**Report on
Indianapolis Power & Light Company's
2019 Integrated Resource Plan**

Submitted to the IURC on April 16, 2020

On behalf of Citizens Action Coalition and Earthjustice

Figure 2. Summary of Bids Received. NIPSCO 2018 IRP, p. 55.

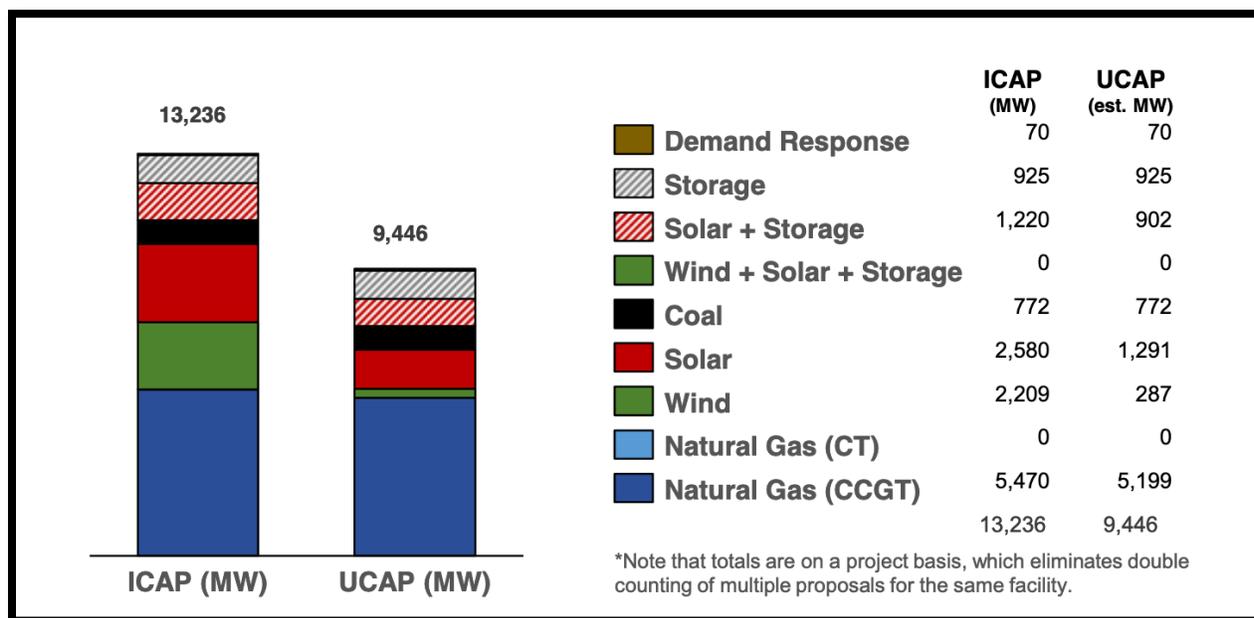
IPL’s 1,500 MW limit over the 20-year planning period is less than the 2,209 MW of wind NIPSCO received just in response to its 2018 all-source RFP to fill its 2023 capacity shortfall. NIPSCO also received bids for 2,580 MW of solar and 1,220 MW of solar + storage hybrid projects (Figure 2)—far more than IPL is even allowing PowerSimm to select over the entirety of the planning period.

IPL’s limit of 1,500 MW for solar and 1,500 MW for wind resources over the 20-year planning period was even stricter than the limits used by I&M in its 2018-2019 IRP—I&M constrained portfolios to 1,700 MW of solar and 2,100 MW of wind.⁹ IPL’s solar constraint is binding for Portfolios 4 and 5, which retire Petersburg Units 3 and 4, respectively. The cumulative solar constraint is binding on Portfolios 3, 4b, 4c, 5b, and 5c and the cumulative wind constraint is

Figure 5. Historical and Forecasted Sales across Customer Classes

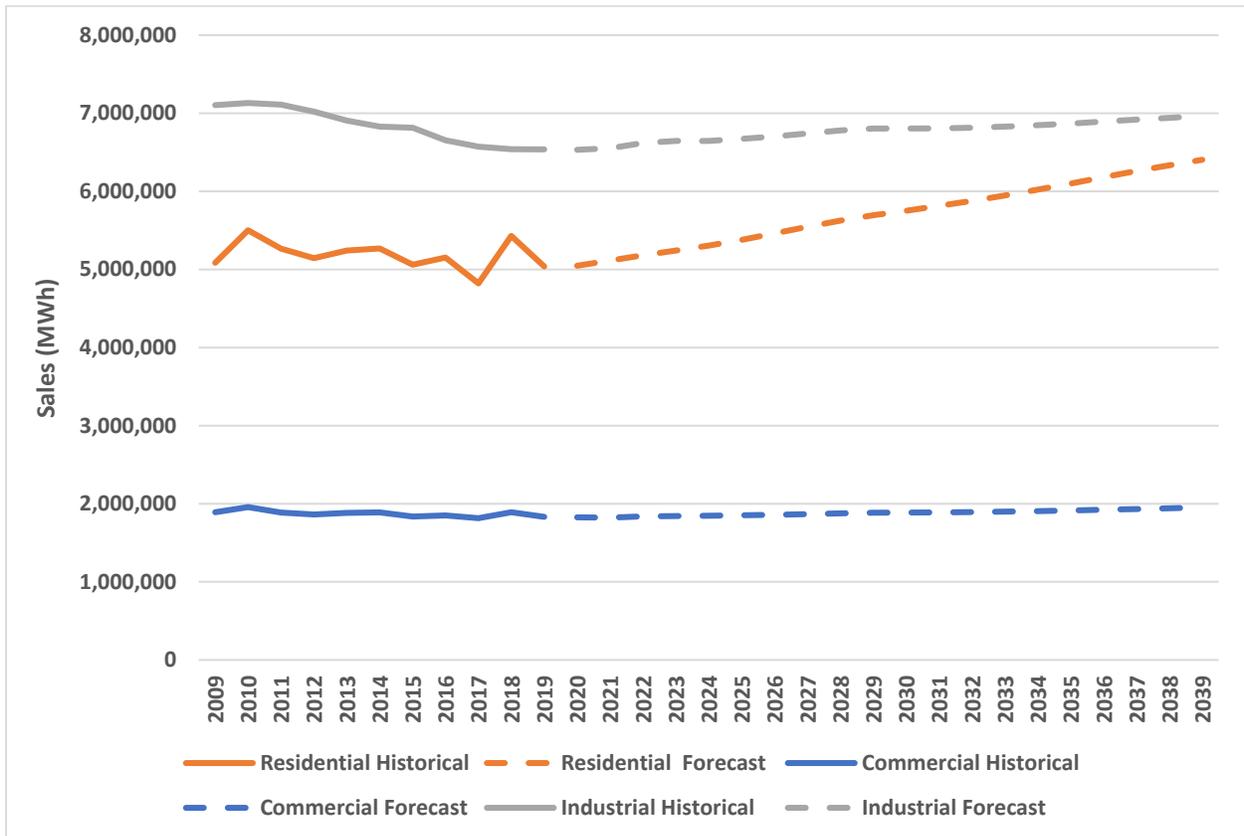
As seen in Figure 5, the strongest sales growth for IPL’s forecast is from the residential customer class.

Given that IPL has experienced essentially flat residential sales since 2009 even as its residential customers have increased by 0.70 percent per year, it seems very unlikely that a 0.80 percent annual increase in customers from 2020 through 2039 would lead to the 1.26 percent average annual growth in residential sales shown in Figure 5.

Figure 6. Historical and Forecasted Number of Residential Customers

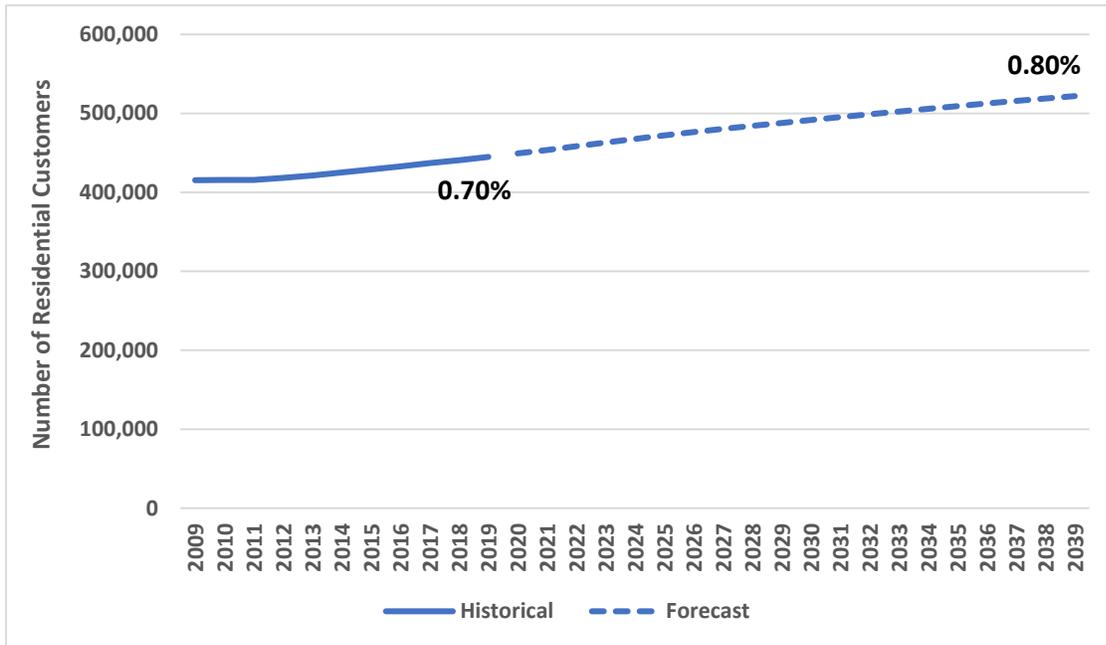
IPL contends that the strong growth in residential sales that it is forecasting is due to additional multifamily apartments.³⁴ IPL cites figures from the Indianapolis Business Journal that apartments in downtown Indianapolis have grown by 250%.³⁵ However, the rate of growth in residential customers historically and the rate forecasted by IPL’s economic data vendor are not all that different. The 2009 to 2019 rate is 0.70 percent, and the forecasted rate through 2039 is 0.80 percent as shown in Figure 6.

Figure 7. Comparison of Historical and Projected Peak Demand³⁶

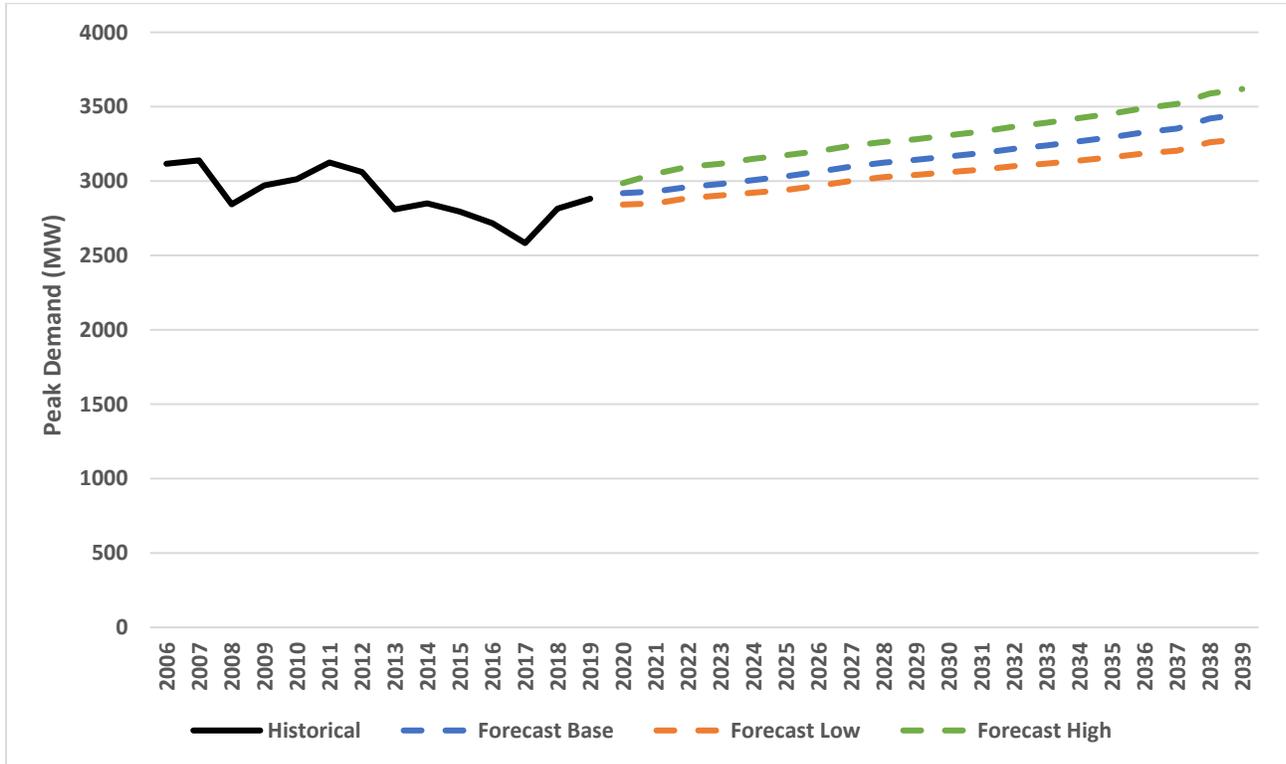
IPL is also projecting growth in its peak demand forecast throughout the planning period. Figure 7 shows the forecast for the base, low, and high cases compared to historical peak demand.

Driven, again, largely by an increase in residential consumption, IPL predicts it will reverse a multi-year trend of falling load. Note that the average percentage increases are given in Table 10, below.

Figure 8. Realistic Achievable Potential Supply Curve⁴¹

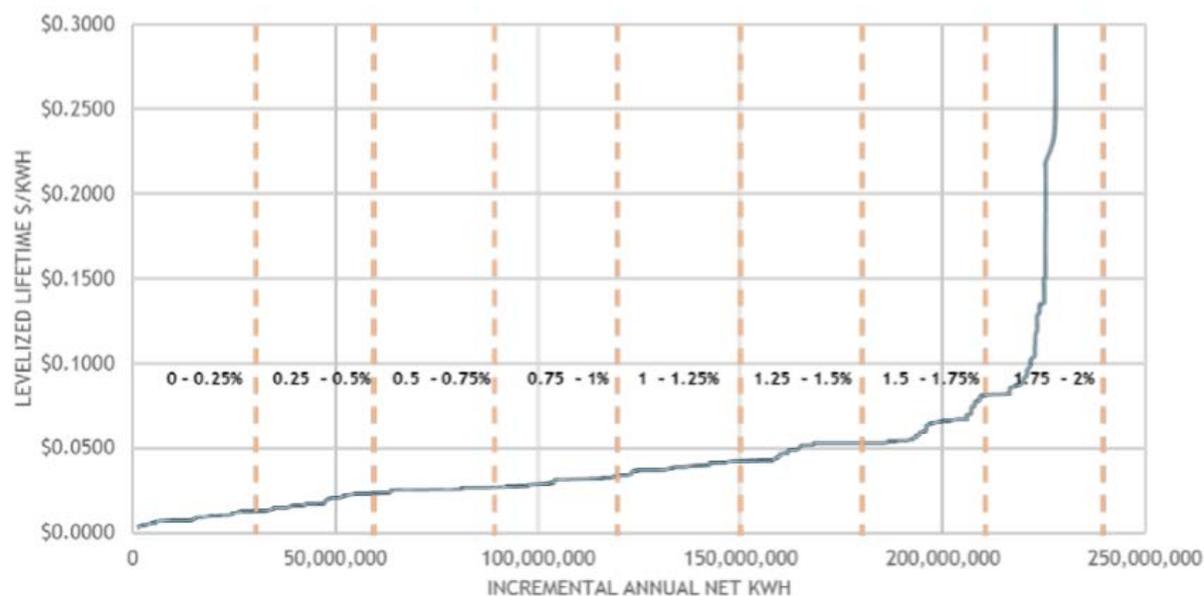
We expressed concern to IPL about using this approach since it does not reflect how IPL actually implements its DSM programs and that it would, therefore, distort the selection of EE. The first bundle of savings that IPL achieves would contain a mix of cost-effective measures, not merely the savings from the least expensive measures. IPL implements a diverse portfolio of measures, some of which would be included in Bundles 1-4, but also others that appear in higher cost bins. For example, there are numerous measures assigned to the Residential Multifamily Direct Install energy savings program. For this program, measures are assigned to Bundle 2 through Bundle 7.⁴² Since IPL’s preferred plan includes only the savings up to and including Bundle 4, will the measures that would otherwise be included in this program contained in Bundles 5 through Bundle 7 just be eliminated? And, if not, will program savings be increased to account for the

It is not credible to argue that the bundles are merely proxies for overall program savings of similar costs. First, that assumes that the shape of all measures are substitutable for each other. Even more importantly, if Figure 8 was reworked to present the MPS savings by program type, then the supply curve of EE would look much more flat. This is because the less expensive measures would average out the costs of the more expensive measures, the result of which would almost certainly be the selection of additional EE as long as not all the bundles are “optimal”.

Figure 9. Comparison of Historical DSM Achievements and Savings from IRP ⁴⁷

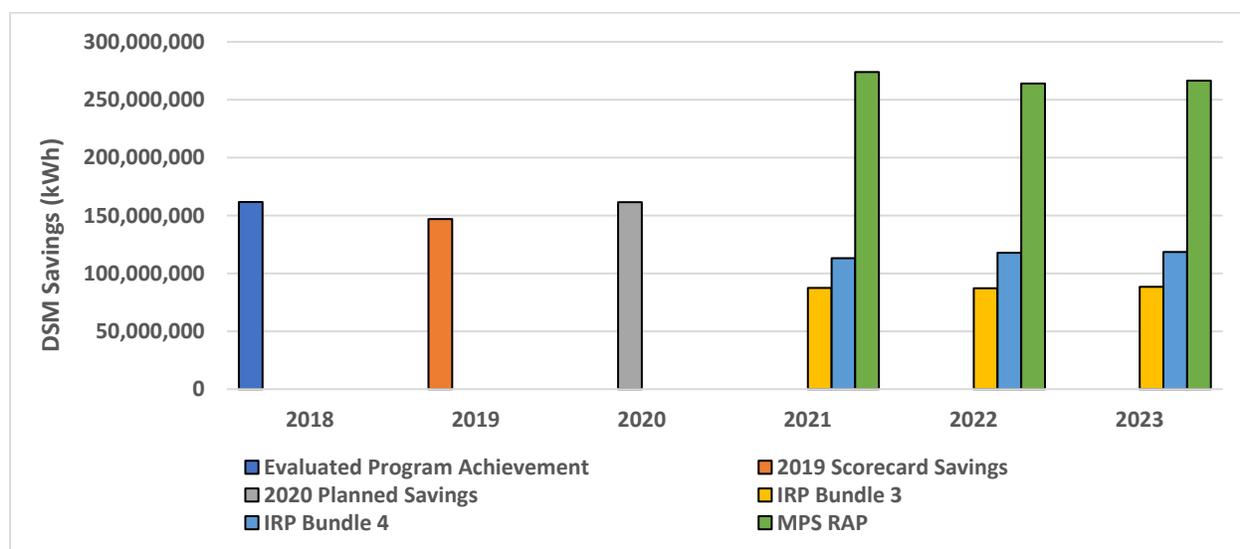
Figure 9 compares IPL’s 2018 actual program achievement savings, 2019 savings reported in its scorecard, 2020 planned savings goal, the Realistic Achievable Potential (“RAP”) identified in its MPS, the savings up to and including Bundle 3, and savings up to and including Bundle 4, separately. The savings from Bundles 3 and 4 are materially less than: IPL’s historical savings in 2018 and 2019; IPL’s planned savings goal for 2020; and the MPS RAP. We believe this is a direct result of the way the bundles were defined in the modeling as described above.

Figure 12. Comparison of IPL Existing Demand Response Resources to MPS Achievable Potential⁵⁹

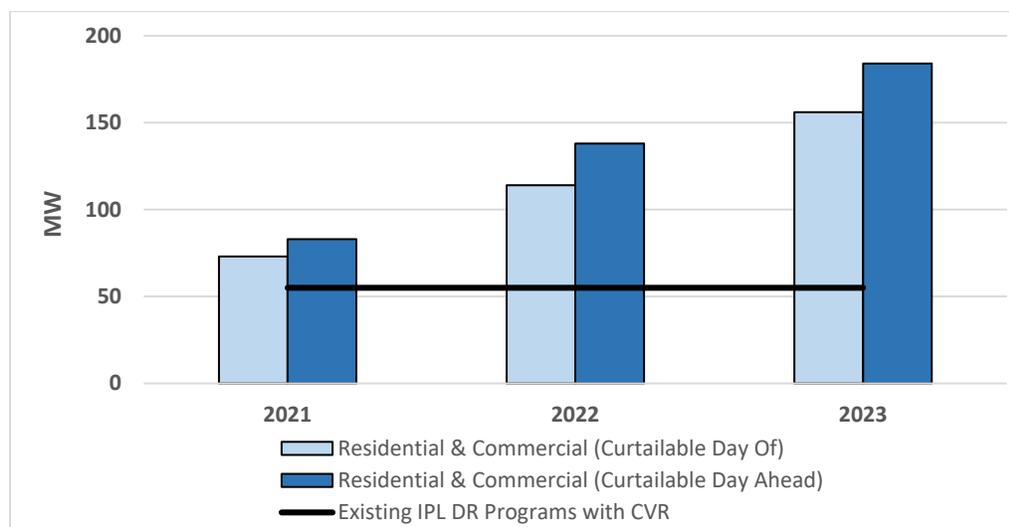
Given the Realistic Achievable Potential identified in the MPS, IPL’s existing demand response falls short. Figure 12 compares IPL’s existing demand response to the Achievable Potential identified in the MPS. Please note that the MPS identifies two different levels of Achievable Potential – one that considers residential programs plus “day of” curtailable programs for commercial customers and one that considers residential programs plus “day ahead” curtailable programs for commercial customers. The two blue bars represent the range of demand response potential, taking into consideration the different curtailment notification. The solid black line represents IPL’s existing demand response programs. Based on the potential identified in the MPS, there are additional savings from demand response programs for IPL.
